A GFT COMPANY

December 15, 2008

⚠ WARNING PBV trunnion supported ball valves manufactured during the period 1990 through 1997 have the potential for a trunnion and gland cap screw failure if the valve is installed in a sour service as defined by NACE MR0175 or is installed in a buried service with applied cathodic protection.

Figure 3 - Modified schematic of hydrogen embrittlement failure mechanism (Note – Shows no susceptibility to hydrogen embrittlement due to decreased material hardness).

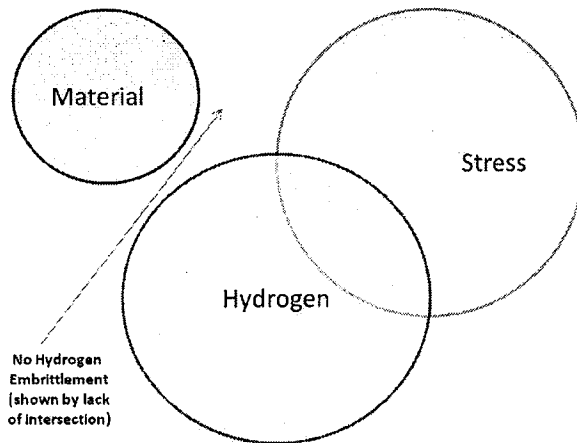
This atomic hydrogen does not cause failure in the other valve components because these components are made from steels of lower hardness and therefore they have a lower susceptibility to hydrogen embrittlement than the steel in the cap screws. Using the schematic presented previously to analyze the susceptibility of the other valve components to hydrogen embrittlement, the three regions in the diagram form no intersection (See Figure 3). This same diagram illustrates why the lower hardness replacement steel cap screws are not susceptible to hydrogen embrittlement.

We recommend that the standard high strength steel cap screws used in trunnion supported, three-piece style PBV ball valves manufactured during the period 1990 through 1997 be replaced with lower hardness cap screws if the valve is installed in a sour service as defined by NACE MR0175 or is installed in a buried service with applied cathodic protection. PBV will provide these cap screws at no cost
